Appl. No. 10/790,844

Amdt dated January 20, 2006

In Reply to Office Action dated September 21, 2005

Amendments to the Drawings:

Fig. 1

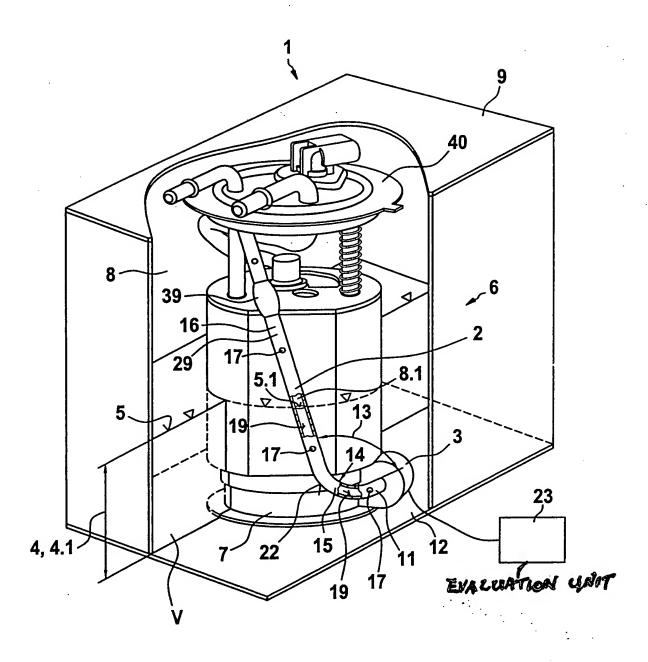
The two attached sheets of drawings include changes to Figs. 1 and 2 and replace the

original sheets including Figs. 1 and 2. In Figs. 1 and 2, the label "evaluation unit" has been

added to box 23.

Figs. 1 and 2 of the drawings have been corrected to add the label "evaluation unit" to

box 23. The claims have also been amended to change reference numeral "18" to read "6." The
